Player Wills

Stage 1 Road Safety Audit

Client:	Systra
Project Title:	Player Wills
Document Title:	Stage 1 Road Safety Audit
File Name:	200929-20640-RP-0002_Stage_1_Road_Safety_Audit_P01

Figure 2.6: Angled pedestrian crossing point

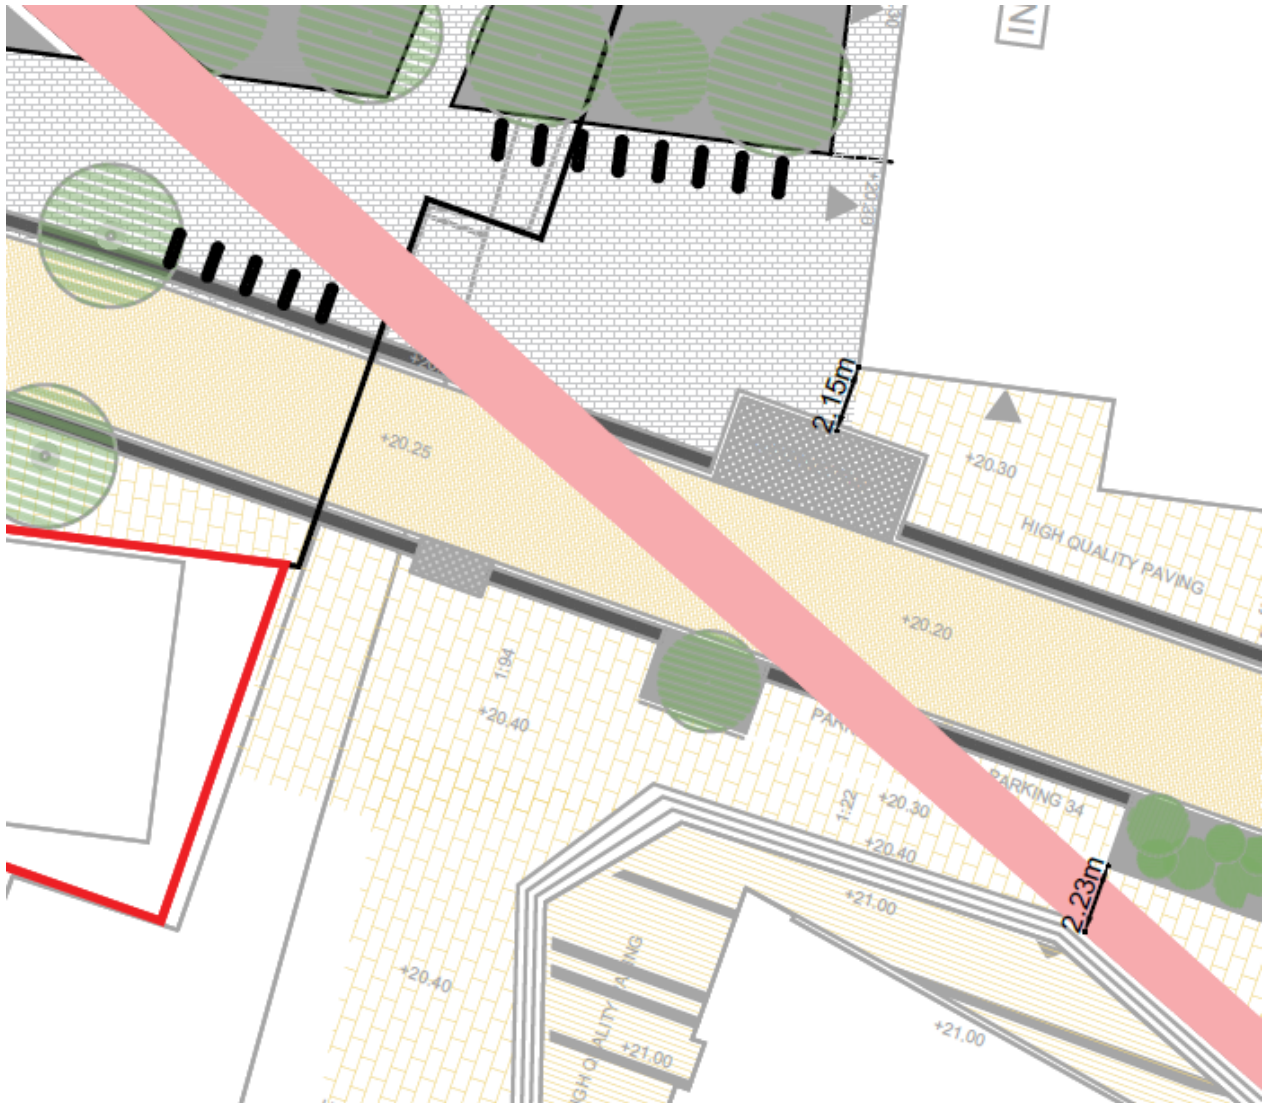
2.6 Problem: Angled pedestrian crossing point

The red paved route through the site crosses the shared space roadway at a diagonal angle. This may result in pedestrians, especially visually impaired pedestrians, making unsafe crossings, with potential for them to come into conflict with road traffic.

Amend the arrangement so that the pedestrian crossing is perpendicular to the shared space roadway, ensuring the shortest crossing route for pedestrians and limiting their exposure to conflict with traffic.

2.5	Yes	Yes	Cul-de-sac sign to be provided as part of the Detailed Design Stage	n/a
2.6	Yes	Yes	This issue has been resolved as shown in the Planning Drawings	n/a

Figure 2.7: Sign placement

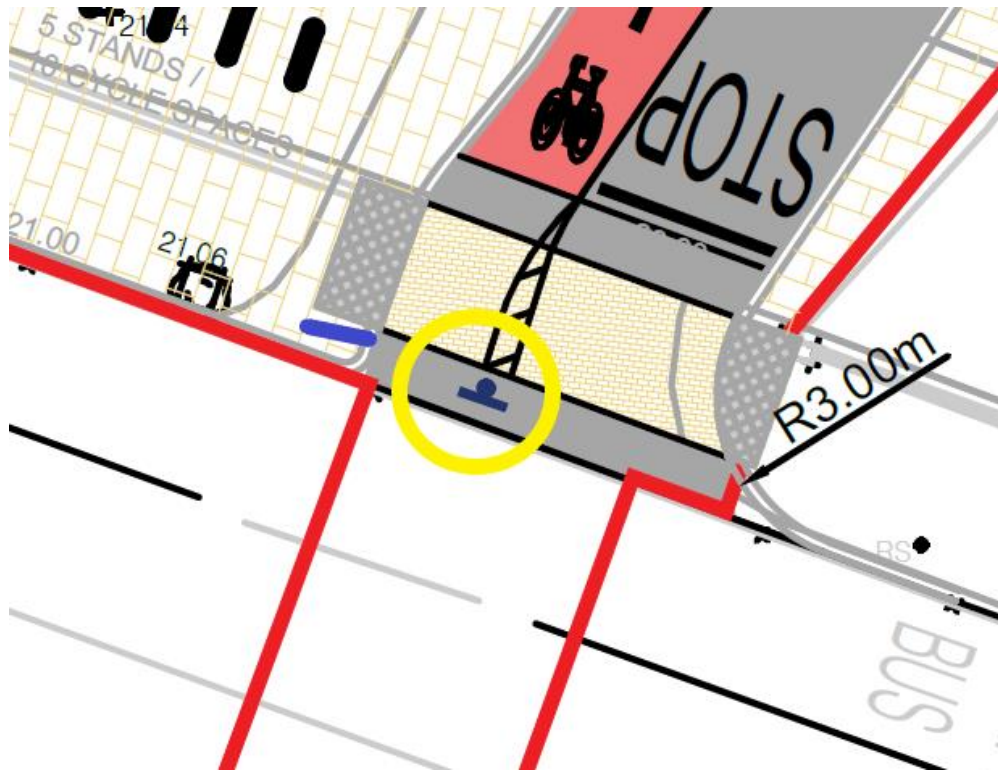
2.7 Problem: Sign placement

There is a proposed sign positioned between the cycleway and the vehicular exit onto South Circular Road. This sign poses a hazard to vehicles and cyclists using this access/exit.

Reposition the sign to the footpath to minimise the potential for vehicles or cyclists coming into conflict with it (indicated with the blue line on the image below).

2.7	Yes	Yes	This issue has been resolved as shown in the Planning Drawings	n/a
2.8	Yes	Yes	It is proposed to review the road markings arrangement along the cycle lane as part of the Detailed Design Stage	n/a

Figure 2.8: Cycle arrows

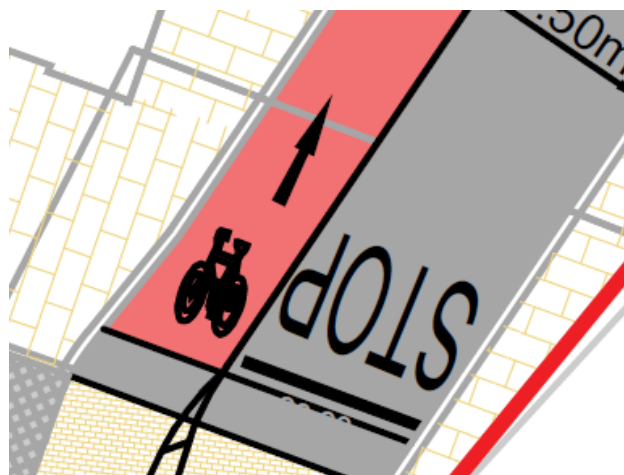
2.8 Problem: Cycle road markings

The cycle directional arrows are considered unnecessary and pose a risk of cyclists slipping on a wet road surface due to reduced grip. The cycle symbols give a sufficiently clear indication of the intended direction of travel.

Remove the directional arrows.

Figure 2.9: Orientation of stop line centreline

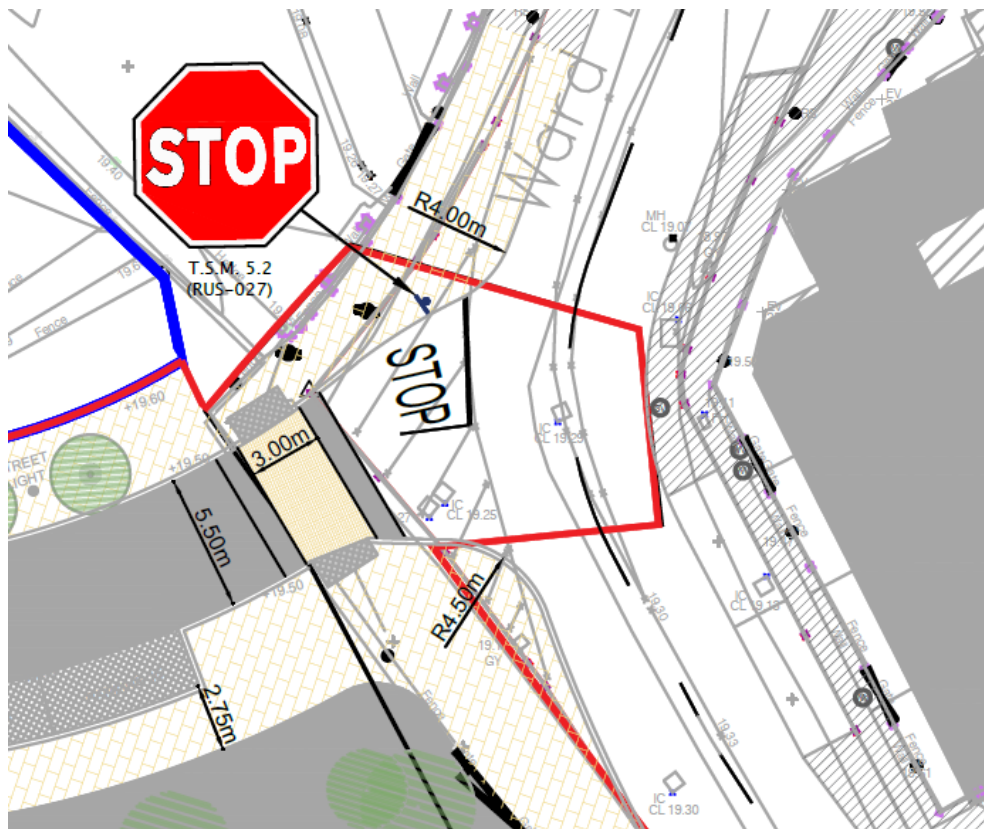
2.10 Comment

Review orientation of the stop line centreline to ensure it follows the centreline of the proposed access.

2.9	Yes	Yes	Wayfinding to be provided as part of the Detailed Design Stage	n/a
2.10	Yes	Yes	This issue has been resolved as shown in the Planning Drawings	n/a
2.11	Yes	No	Due to the low speed and volumes on this road, we are proposing that cyclists will share the road space as throughout the site when travelling southbound, therefore there is no need to provide a 2-way cycleway (2.5m wide). The potential narrowing of the traffic lane to 3m wide will be investigated at the Detailed Design Stage	Yes
2.12	Yes	Yes	Signage arrangement at the entrance of the development to be provided as part of the Detailed Design Stage	n/a

Figure 2.10: Lane widths

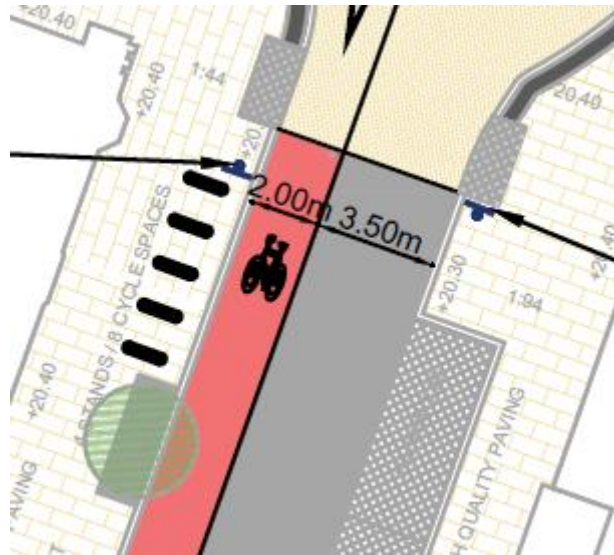
2.11 Comment

The one-way vehicular route exiting onto South Circular Road is shown as 3.5m alongside a 2m one-way cycleway. 3m would be sufficient for the one-way vehicular route. Reducing this to 3m would allow for increasing the cycleway to 2.5m, which would permit a two-way cycle track.
